Response to Comments

**Radiation Survey and
Remedial Assessment
Northwest Property Area**

**Fansteel, Inc.
Muskogee, Oklahoma**

Project No. 111
May 1994

Boring Log

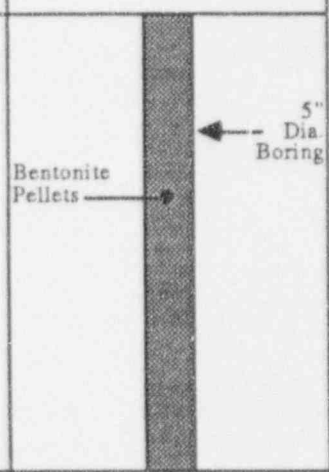
8. Well sampling data presented in the Northwest Property Area report for MW-151D appear to be suspect due to large variations in analytical results. As a result, an additional sample has been collected from this well and submitted to Accu-Labs Research, Inc. for analysis. The results of this analysis are presented in Table 3 enclosed with this report. The data presented in Table 3 do not indicate the presence of elevated radioactivity in this well.

10. The well log for MW-151D has been revised and is enclosed with this letter as Attachment A.
11. Fansteel is aware of no drums of waste or waste materials being buried on or near the Northwest Property Area. The comment in the report regarding the potential for drums or wastes to be buried on site was made in response to an allegation made by a regulatory agency representative. Fansteel has investigated the areas of the site where waste materials have allegedly been buried (including the installation of test pits, soil borings, and geophysical and radiological surveys) and have discovered no evidence to substantiate these allegations.
12. The piping systems identified in Figure 12 of the work plan are associated with site utilities and storm water management. These piping systems have not been used for the conveyance of licensed materials.
